DDK(THAILAND) Ltd. DDK (THAILAND) LTD. Navanakorn Industrial Estate 55/25 Moo 13, Klong-Luang, Pathumthani 12120 Thailand		MRR/MIR Report <input checked="" type="checkbox"/> Material Rejection Report <input type="checkbox"/> Material Improvement request		Issue No: QA-18-09-003 Date: 5 Sep'18 Supplier: Suzuki Co.,Ltd. Issue By: Prapapan P.																																																													
Defect Mode Structure differenc from drawing			Nonconformity Degree: <input checked="" type="checkbox"/> Critical <input type="checkbox"/> Major <input checked="" type="checkbox"/> Minor

INITIAL REPORT

Issue No.	QA-18-09-003
Claimed Date	5 Sep'18
Revision No.

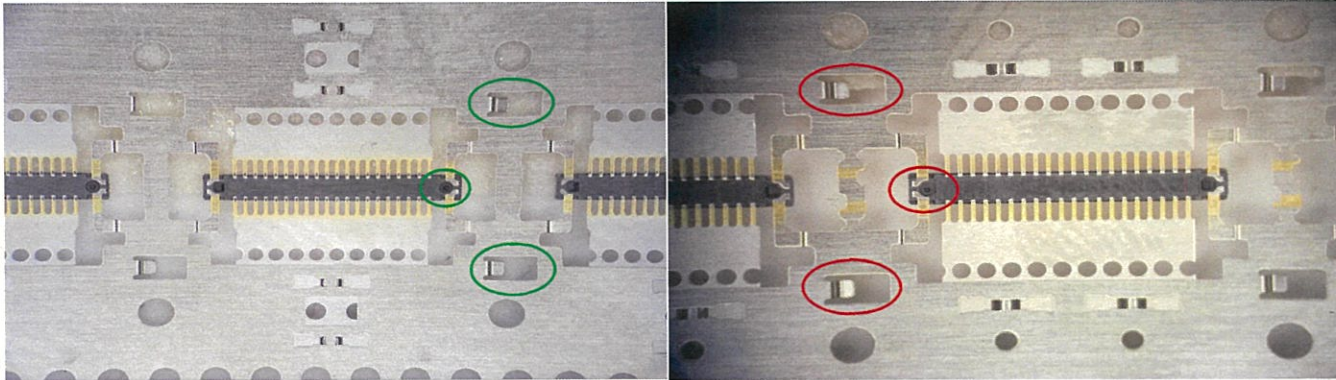
Simulation test detail

No.	Action detail	Person in-charge	Action Date
	Review of winding direction confirmation rule after plating.	SANNO CO.,LTD	14 Sep '18
